Subject: Attention: General Manager - Ref. DA 10.2023.28.1 11 Seale St Burwood

Development Application 10.2023.28.1 - 11 Seale Street, Burwood

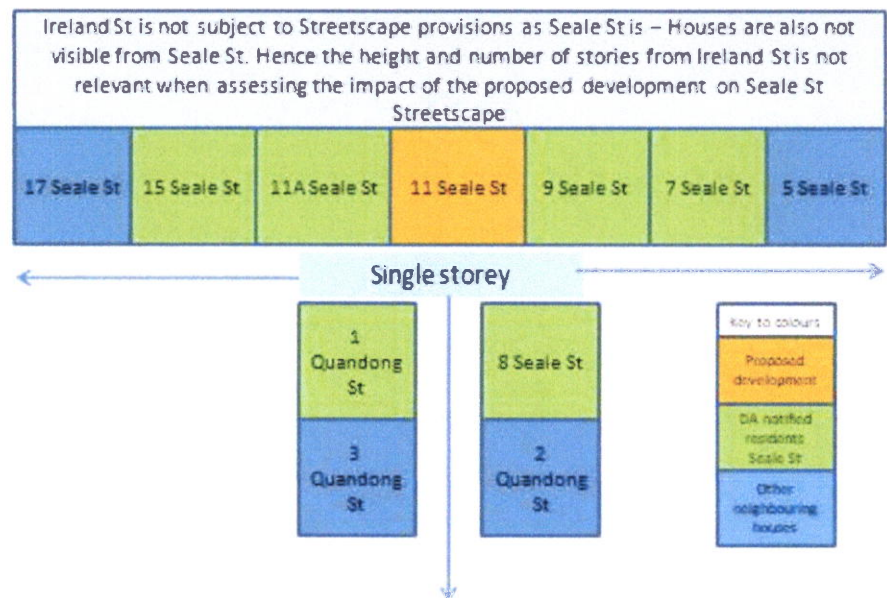
The diagram below clearly shows that a two-storey development is not typical of the dwellings surrounding the proposed development which are all single storey hence the new development is not complaint to provision P8 which states *A full two storey single dwelling would not be considered appropriate where surrounding single dwellings are mostly single storey.*

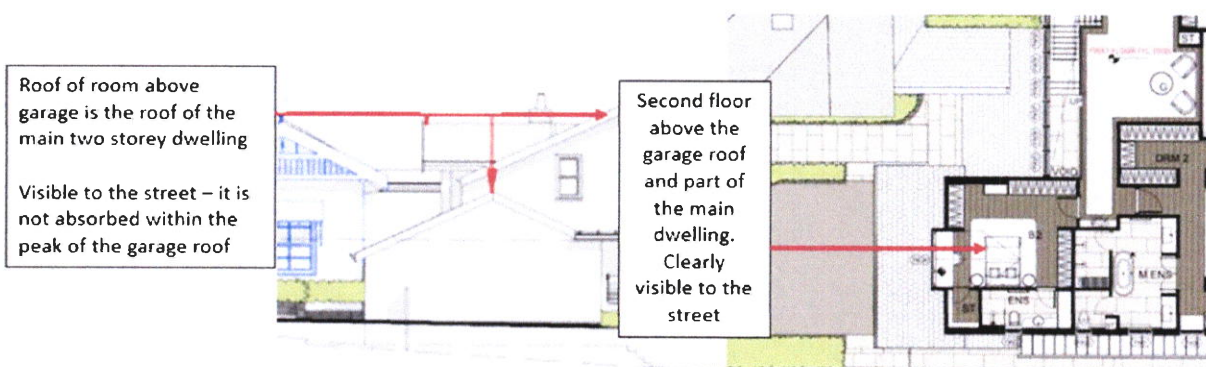
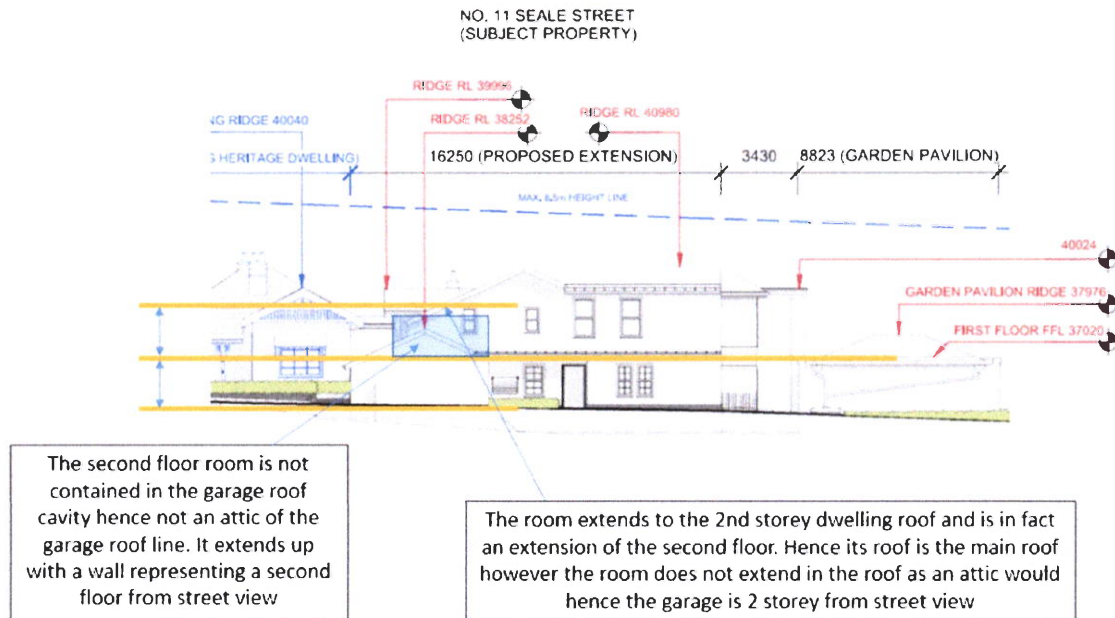
The development application also proposes a double garage with an attic and dormer window to give the impression that it is single storey. However, on analysis we can see that this is not correct, and it does in fact give an impression of two storeys. The intention of an attic is to integrate it into the existing roof profile which is that of the garage. We see by the picture that there are two distinct roof profiles with one roof separated by a vertical wall with the other roof. The other roof being an extension of the main two storey dwelling. Hence the roof of the upper room is in fact the main roof of the dwelling. The wall runs across the garage and does not just encompass the dormer window. The window also extends from the wall. This can be seen in the following pictures and diagrams.

The following picture shows a typical attic with dormer windows which is clearly different to the above picture.

It is clear that the two-storey dwelling, and two-storey garage are visible to the street hence not compliant with the streetscape. The Collins Dictionary also defines Two-Storey as a building with two floors or levels which the garage has

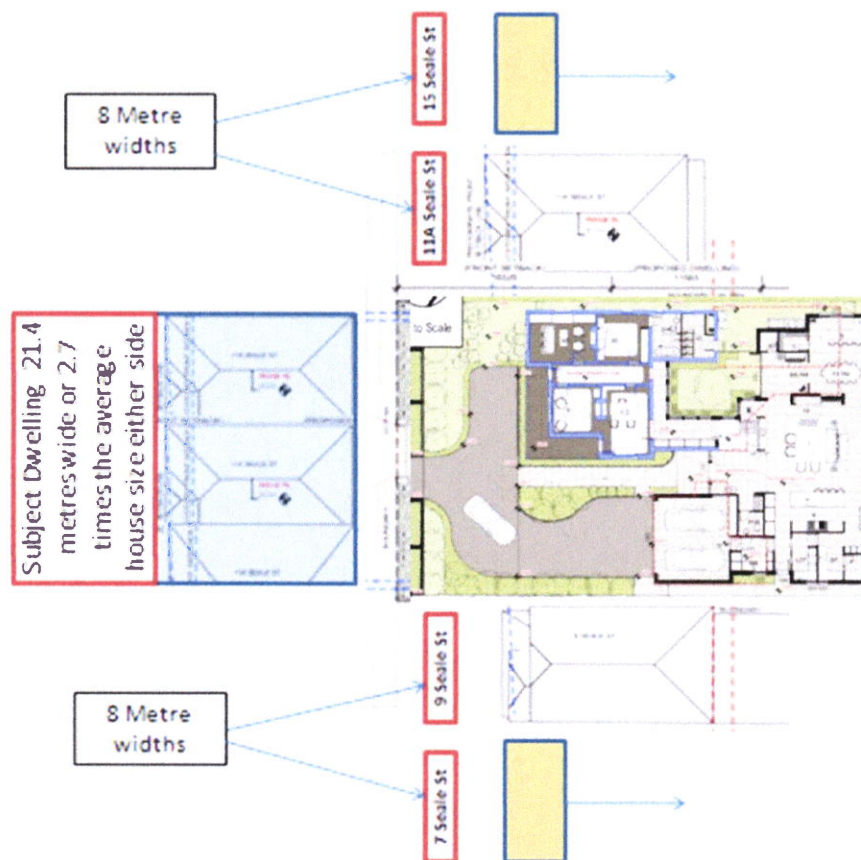
of 21.4m for the dwelling being applied. In comparison neighbours on either side 7, 9, 11A and 15 have driveways running beside the dwelling hence reducing dwelling frontage to 8m across. The built area frontage represents almost 3 times the typical streetscape frontage. Hence there is no justification for this non-compliance as it is out of character with the streetscape and neighbours. The area would be better served by applying additional vacant space around neighbours.

Approval of the proposed built area would be contrary to the objective O1 - To control the building bulk of single dwellings and additions. The proposed development is not compatible or complimentary and will negatively impact the character of the Seale St Streetscape

Footprint of original rear portion of cottage the same as it was in 1943 (pre 1943 pictures not available)

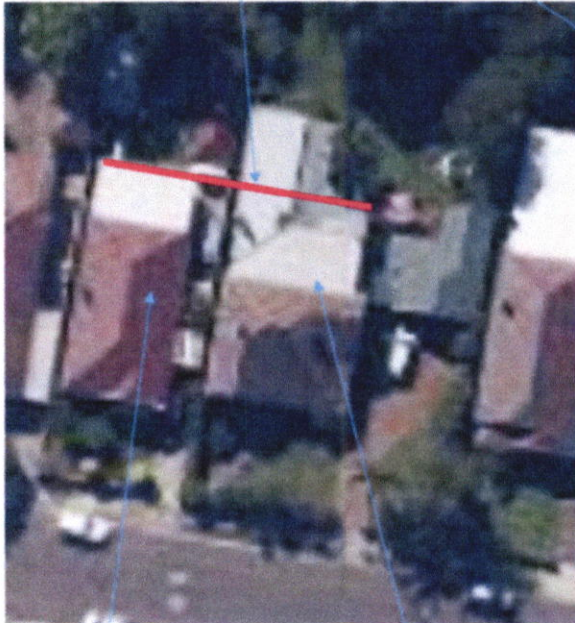
Hence the original rear portion of the cottage is of high heritage significance. This is the same with the garage as the streetscape view width is retained as a double garage.
